10.4 Other Features of Steam and Power Conversion

The information in this section of the reference ABWR DCD, including all subsections, tables, and figures is incorporated by reference with the following departures and supplements.

Figure 10.4-1 Main Condenser Evacuation System

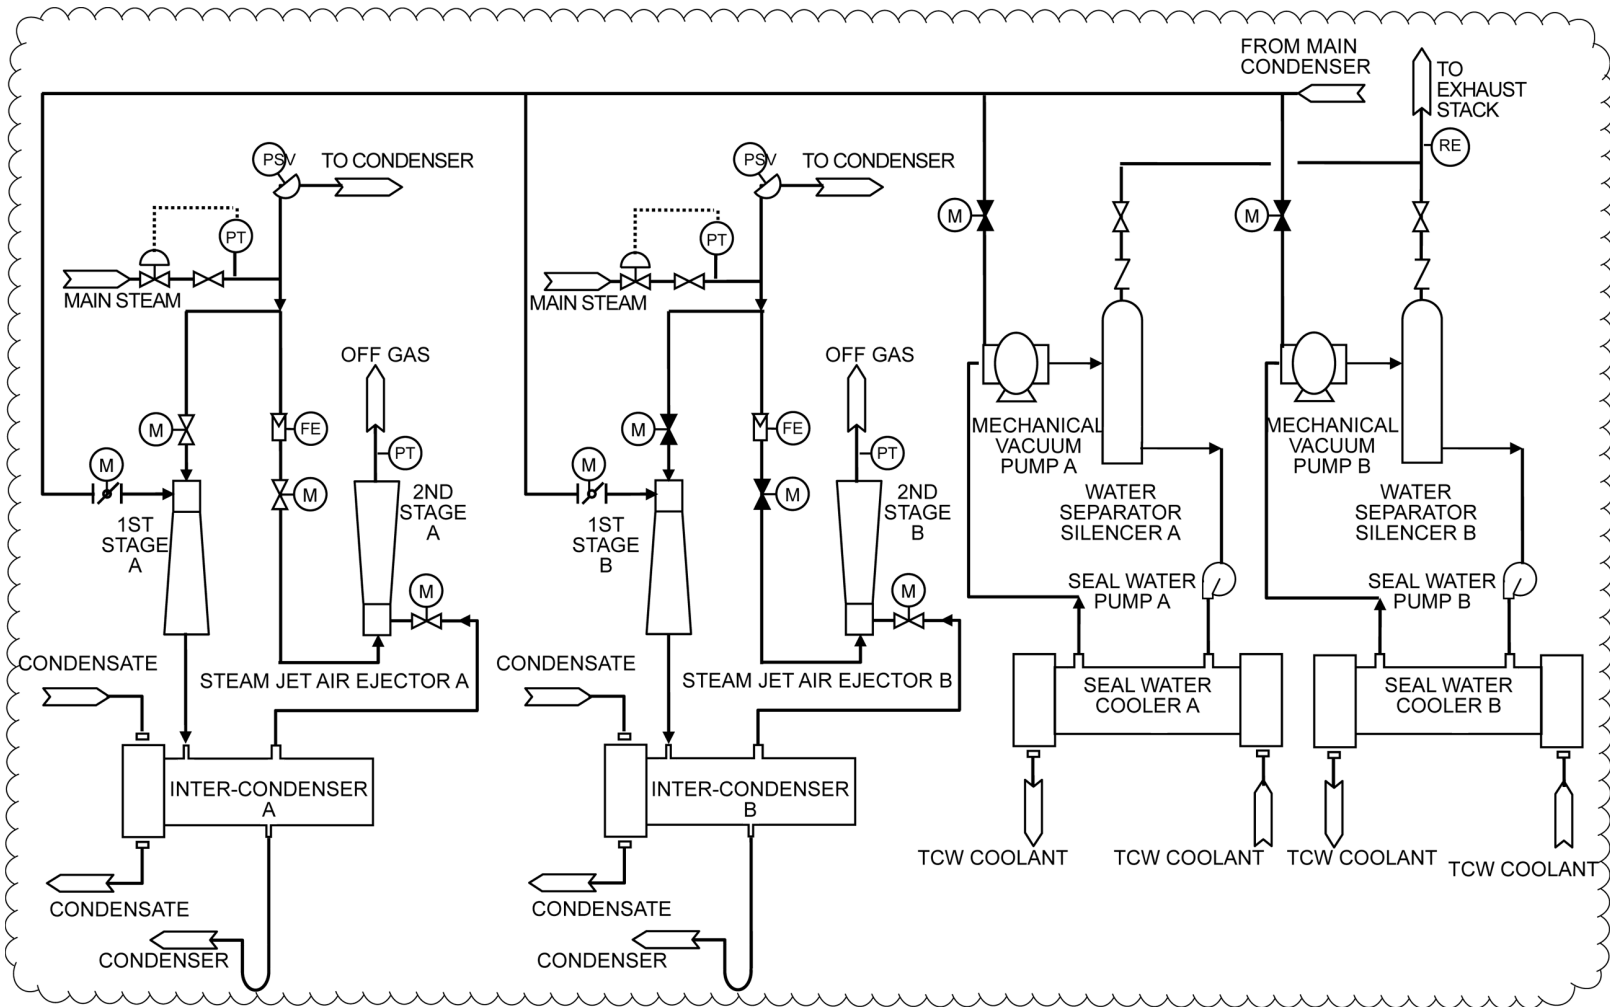
STP DEP 10.4-3 (Table 10.4-2, Figure 10.4-1)

The MCES (figure 10.4-1) consists of two 100%-capacity, double stage, steam jet air ejector (SJAE) units (complete with ~~intercondenser~~ intercondensers) for power plant operation, and ~~a two, 100% mechanical vacuum pump pumps~~ for use during startup. The last stage of the SJAE is a noncondensing stage. One SJAE unit is normally in operation and the other is on standby.

During the initial phase of startup, when the desired rate of air and gas removal exceeds the capacity of the steam jet air ejectors, and nuclear steam pressure is not adequate to operate the SJAE units, the mechanical vacuum ~~pump pumps~~ establishes establish a vacuum in the main condenser and other parts of the power cycle. The discharge from the vacuum ~~pump pumps~~ is then routed to the ~~Turbine Building compartment exhaust system~~ plant vent stack, since there is then little or no effluent radioactivity present. Radiation detectors in the ~~Turbine Building compartment exhaust system~~ Offgas collecting duct and plant vent alarm in the main control room if abnormal radioactivity is detected (Section 7.6). Radiation monitors are provided on the main steamlines which trip the vacuum ~~pump pumps~~ if abnormal radioactivity is detected in the steam being supplied to the condenser.

The SJAEs are placed in service to remove the gases from the main condenser after a pressure of about ~~0.034 to 0.051 MPa~~ 7kPa absolute or less is established in the main condenser by the mechanical vacuum pumps and when sufficient nuclear steam pressure is available.

Figure 10.4-2 Turbine Gland Seal System

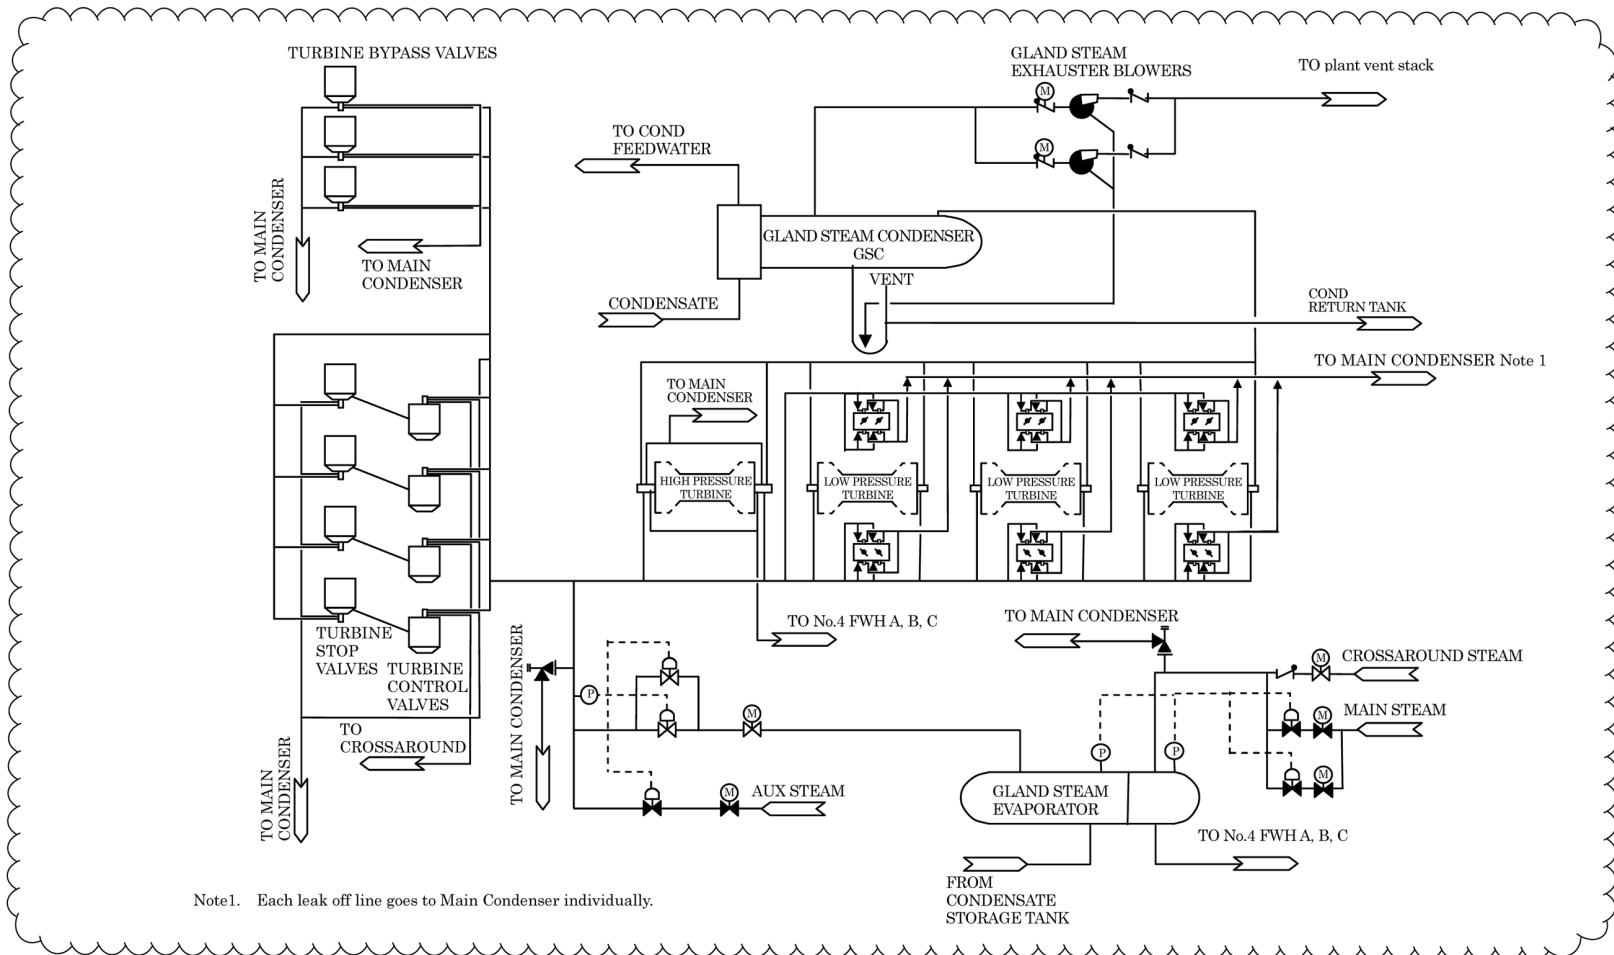
STD DEP 10.4-1 (Figure 10.4-2)

The turbine gland seal system is illustrated in Figure 10.4-2. The turbine gland seal system consists of a gland steam evaporator, sealing steam pressure regulator, sealing steam header, a gland steam condenser with two full-capacity exhausters blowers, and the associated piping, valves and instrumentation.

Figure 10.4-3 Circulating Water System

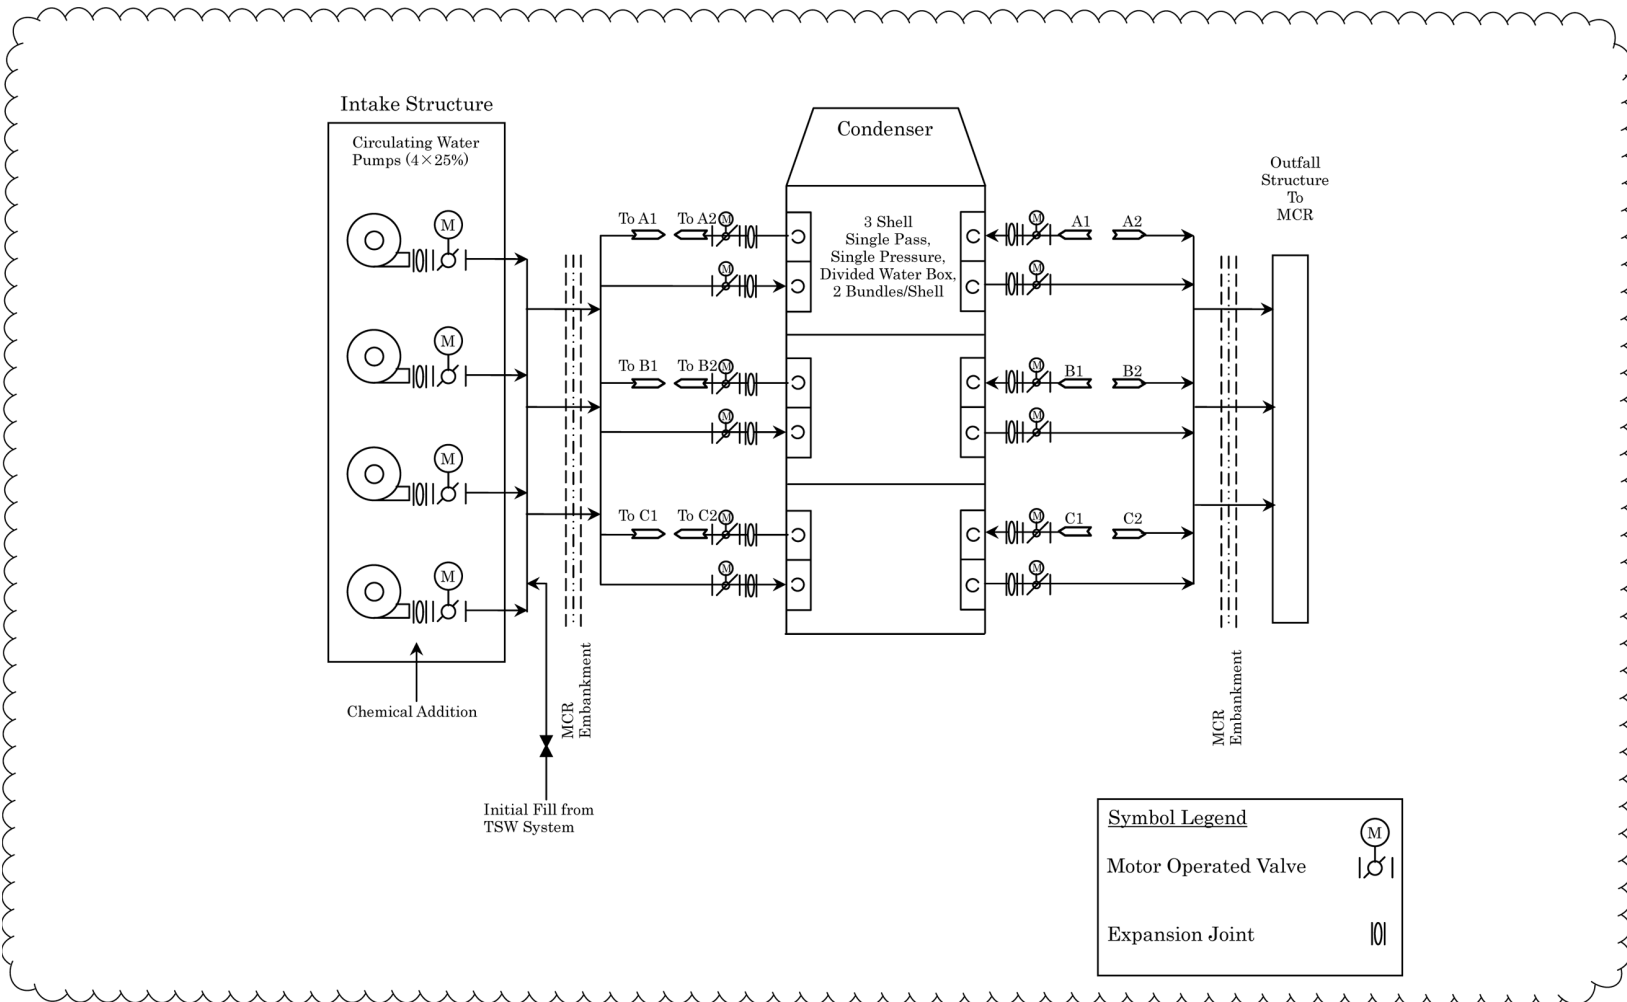
STP DEP 10.4-2 (Table 10.4-1, Table 10.4-3, Figure 10.4-3)

~~The three condenser shells are designated as the low pressure shell, the intermediate pressure shell, and the high pressure shell. The three condenser shells are cross-connected to equalize pressure. Each shell has at least two tube bundles. Circulating water flows in series~~ parallel through the three single-pass shells (Figure 10.4-3).

The Circulating Water System (Figure 10.4-3) consists of the following components: (1) ~~screen house~~ intake structure and intake screens, pumps, (2) condenser water boxes and piping and valves, (3) tube side of the main condenser, (4) water box fill and drain subsystem, and (5) related support facilities such as for system water treatment, inventory blowdown and general maintenance.

The cooling water is circulated by ~~at least three~~ four 25% capacity fixed speed motor-driven pumps per unit.

Four 25% capacity fixed speed circulating water pumps per unit discharge into a common header shown in Figure 10.4-3. The discharge of each pump is fitted with a motor operated butterfly valve. The circulating water is pumped through the main condenser and back to the MCR via a discharge outfall at a nominal rate of 272,550 m³/h per unit. To provide capability for condenser waterbox isolation, isolation valves are located on the circulating water inlet and outlet lines.

Figure 10.4-5 Condensate System

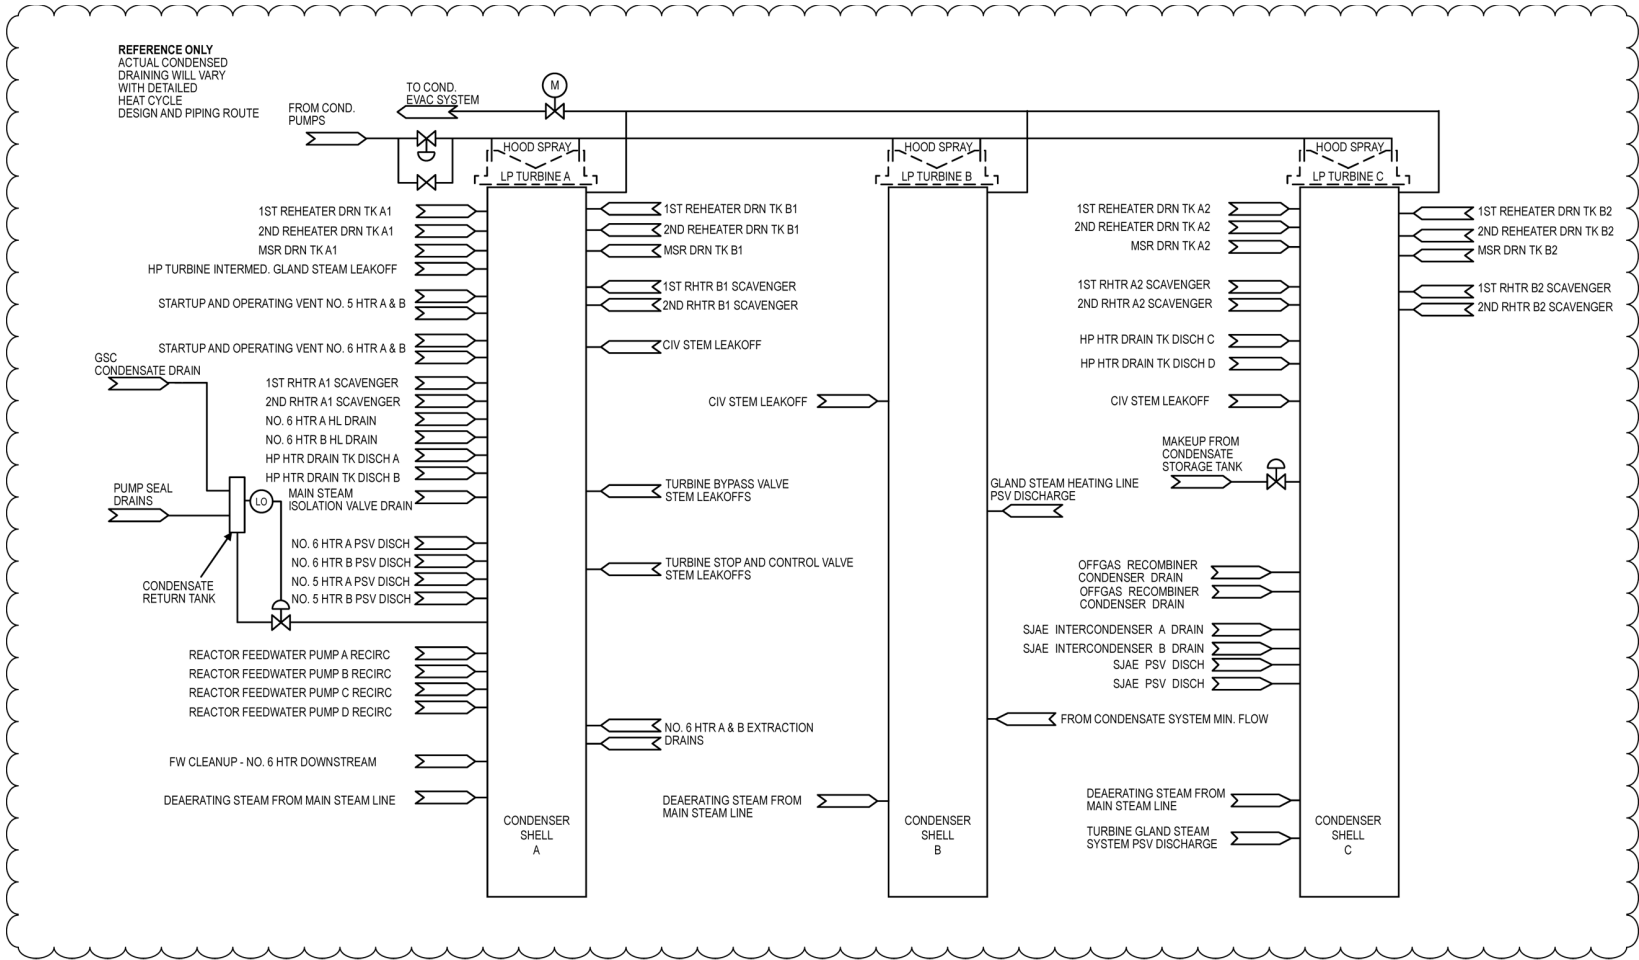
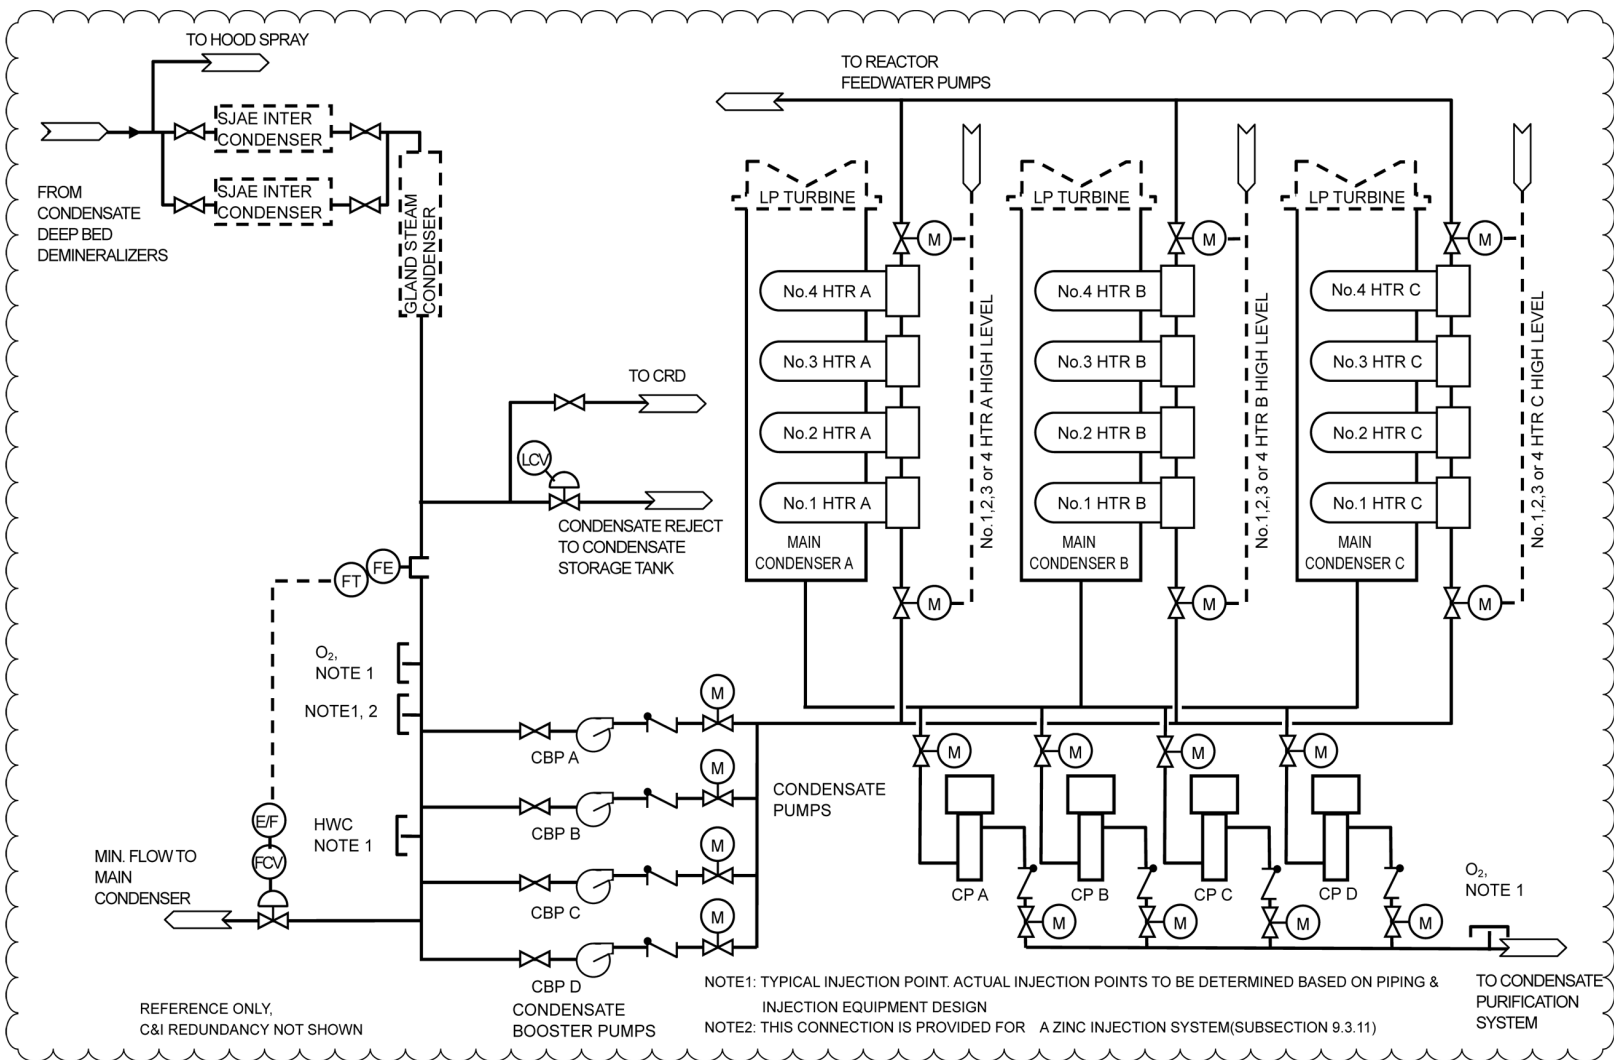
STD DEP 9.2-3 (Figure 10.4-5)

STD DEP 10.4-5 (Tables 10.4-4, 10.4-5 and 10.4-6, Figures 10.4-5, 10.4-6, 10.4-7, and 10.4-8)

The Condensate and Feedwater System (Figures 10.4-5 and 10.4-6) consists of the piping, valves, pumps, heat exchangers, controls and instrumentation, and the associated equipment and subsystems which supply the reactor with heated feedwater in a closed steam cycle utilizing regenerative feedwater heating. The system described in this subsection extends from the main condenser outlet to (but not including) the seismic interface restraint outside of containment. The remainder of the system, extending from the restraint to the reactor, is described in Chapter 5. Turbine cycle steam is utilized for a total of six stages of closed feedwater heating. The drains from each stage of the low-pressure feedwater heaters are cascaded through successively lower pressure feedwater heaters except the lowest and second lowest pressure feedwater heaters which drain to the low pressure heater drain tanks for each string. The drains from each low pressure heater drain tank flow into the external drain coolers of each lowest pressure feedwater heater and finally to the main condenser. The high pressure heater drains are pumped backward to the reactor feedwater pumps suction. The cycle extraction steam, drains and vents systems are illustrated in Figures 10.4-7 and 10.4-8.

The CFS consists of four ~~33-50%~~ 33% capacity condensate pumps (three normally operating and one on automatic standby), four 33% capacity condensate booster pumps, (three normally operating and one on automatic standby). ~~three normally operated 33-65%~~ four 33% capacity reactor feedwater pumps (three normally operating, one on automatic standby), four stages of low-pressure feedwater heaters, and two stages of high- pressure feedwater heaters, piping, valves, and instrumentation. The condensate pumps take suction from the condenser hotwell and discharge the deaerated condensate into one common header which feeds the condensate filter/demineralizers. Downstream of the condensate demineralizers, the condensate is taken by a single header and flows ~~in parallel through five~~ through the auxiliary condenser/coolers, one gland steam exhauster condenser, and two sets of SJAE condensers, ~~offgas recombiner condenser (coolers).~~ The condensate then branches into three parallel strings of low pressure feedwater heaters. Each string
